Studebaker

SERVICE BULLETIN

NO. 251

MODIFICATION OF WATER PUMP - H MODELS

HOOD CONTROL CLIP LOCATION - 1951 PASSENGER CARS

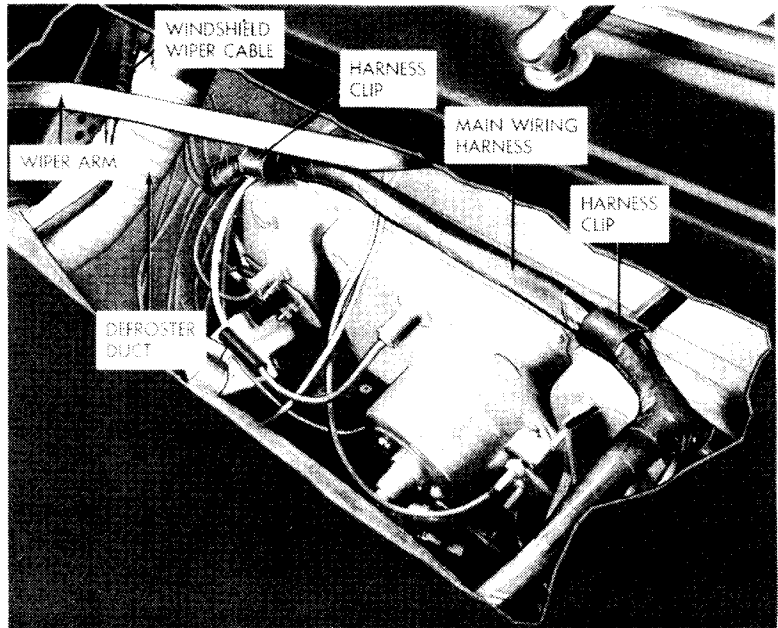
In a few cases the hood lock control cable on 1951 passenger cars became kinked because of a too-sharp curve near the hood latch. In production, the screw hole for the cable clip on the radiator upper air deflector has been moved 1" outward from the center line of the car.

When this condition is encountered on cars produced prior to this change, drill a 3/32" diameter hole and relocate the control cable clip as shown in the illustration.

(ABOVE) FIG. 1 - IMPROPER POSITIONING OF MAIN WIRING HARNESS AND WINDSHIELD WIPER CABLE

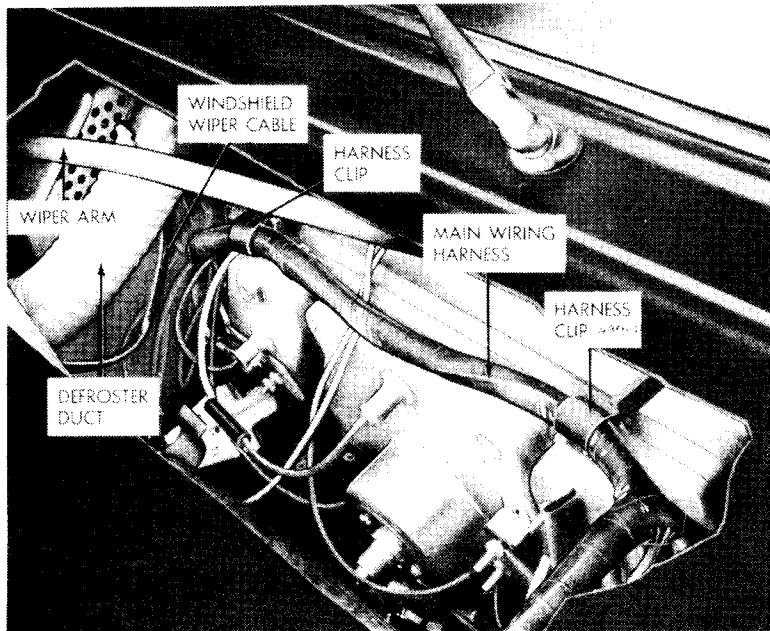
It is possible on cars equipped with electric windshield wipers that the wiper arm on the driver's side of the car may interfere with the main wiring harness or the wiper motor cable. This will occur if, as a result of work or other disturbance of these wires, they are left too high up as shown in Fig. 1.

Main wiring harness must be snug in the two harness clips provided in the two harness clips provided on the instrument cluster housing. Furthermore, the portion of the harness that lies between the clips must be pulled down so that it rests against the top of the speedometer housing. (See Fig. 2.)

Windshield wiper cable must lead out from the main harness underneath the left defroster duct. It must not be allowed to lie across the top of this duct. (See Fig. 2.)

Whenever these wires must be moved to provide working clearance under the cowl, it is important that they be repositioned as follows:
